Technical Memorandum

SUBJECT: Review of Burnside Investments, Inc. Simsboro Aquifer Evaluation Report

DATE: September 1, 2023

Figure 2. Projected DFC Water Level Change at Proposed Burnside Investments, Inc. Well 1

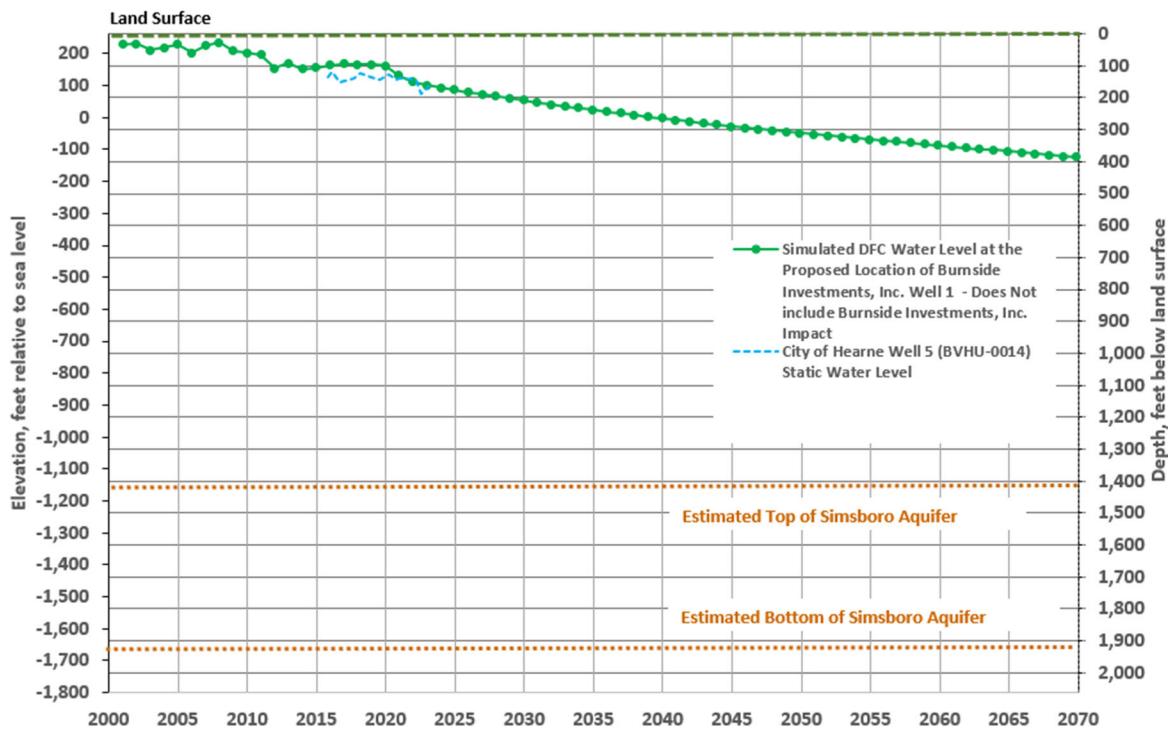
As a way of evaluating potential long-term estimated water level decline at the proposed Burnside wells, AGS plotted the simulated water level decline at each well location based on the 2021 GMA 12 DFC/Modeled Available Groundwater (MAG) projections for the Simsboro Aquifer as shown on the attached Figures 2 through 6. The water level projections shown in the attached figures are from the TWDB approved DFC/MAG run known as GMA 12 “S-19”, but do not include the local impacts from the proposed Burnside wells included in the AER, nor do they include all of the pumping from the Simsboro Aquifer that has been permitted in the area in the past year. The DFC run includes pumping estimates from the Groundwater Conservation Districts in GMA 12 as of about December 2021 that yield DFCs so that the TWDB can estimate the MAG. The detailed assumptions for the DFC simulation can be found in the GMA 12 Explanatory Report (Daniel B.

The graphs illustrate the relationship between the land surface, estimated static water level through time and the estimated base of the Simsboro Aquifer based on review of available local electric logs near the locations of the proposed Burnside wells.

Water levels available from the City of Hearne Well 5 (BVGCD Permit BVHU-0014) are shown on Figure 2. The well screen sands of the Simsboro Aquifer in the depth interval of about 1,128 to 1,275 feet below land surface. BVHU-0014 is located about 5 miles north-northeast of the proposed Burnside Well 5.

Available drawdown in wells in the Simsboro Aquifer will decline over time based on the DFC simulation. In other words, the line with green dots does not include the impact of the proposed Burnside wells. Although not evaluated or discussed in detail herein, these levels of water level decline in wells and artesian head decline in the aquifer will have some impact on vertical leakage, intercepted discharge, reduction in confined and unconfined storage, and potential flow directions in the aquifer. Pumping by the proposed wells will have some of the same type effects on the aquifer.
